AD 94-11-04 Hub Arm Assembly

94-11-04 MITSUBISHI HEAVY INDUSTRIES, LTD.: Amendment 39-8920; Docket No. 94-CE-09-AD.

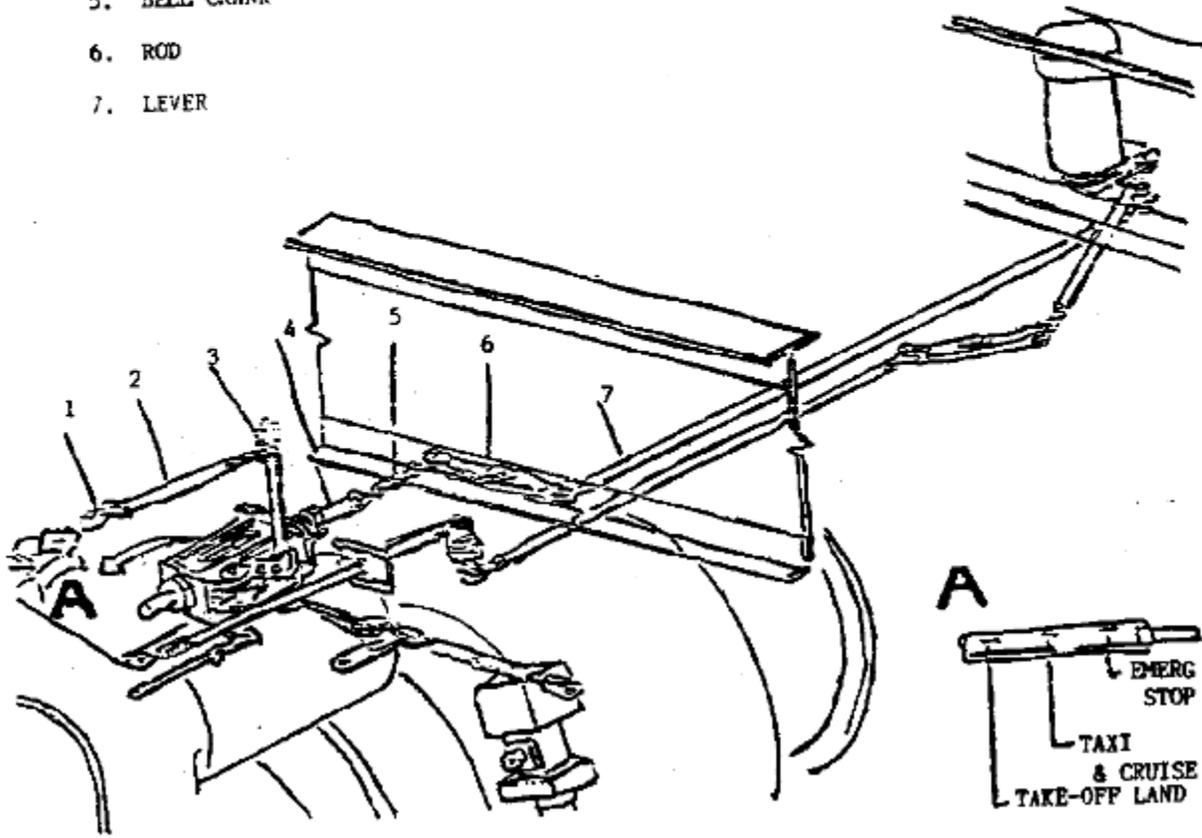
(b) Modify the airframe condition control linkage by adjusting Rod 1 and Levers 2 and 7 as specified in Figure 1 of this AD in accordance with Chapter 6, Section 9.2, of the applicable Mitsubishi MU-2 maintenance manual.

1. ROD
2. LEVER
3. CYLINDER ASSEMBLY
4. ROD (Reference dimension 3.39 inches \pm by 0.02 inches)
5. BELL CRANK
6. ROD
7. LEVER

slip Stripe

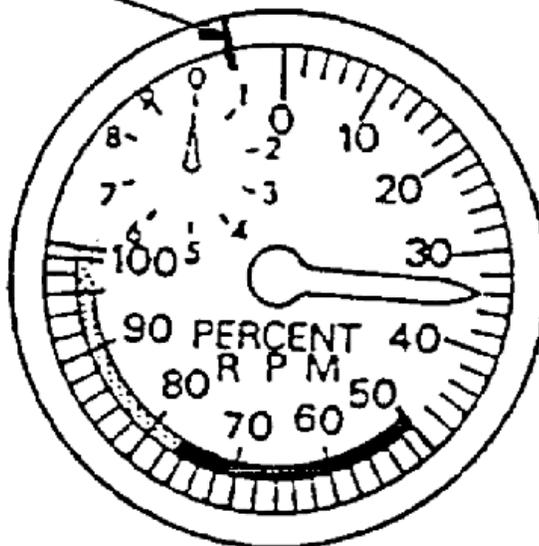
(2) Using white lacquer (MIL-L-7178, color number 511 or equivalent), apply a 1/16-inch wide by 1/4-inch long slip stripe over the tachometer glass and indicator case at the 11:30 o'clock position as specified in Figure 2 of this AD.
